CITY OF REEDLEY
Fax #: 559.637.2139
Email Address: salina.gonzalez@reedley.ca.gov

Request for Interpretation of Contract Documents
RFI #10

Plan Sheet: 5

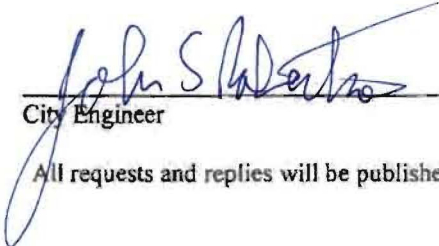
IT IS OUR INTERPRETATION THAT NOTE 2 ON DRAWING SHEET 5 DEFINES
THE CONSTRUCTION WORK TO BE IN THE DRY. OUR PROPOSAL WILL NOT
INCLUDE COFFERDAMS AND/OR UNDERWATER WORK.

The assumption is that the in channel flow elevation will be below
the construction area and there will not be a need for cofferdams
or underwater work.
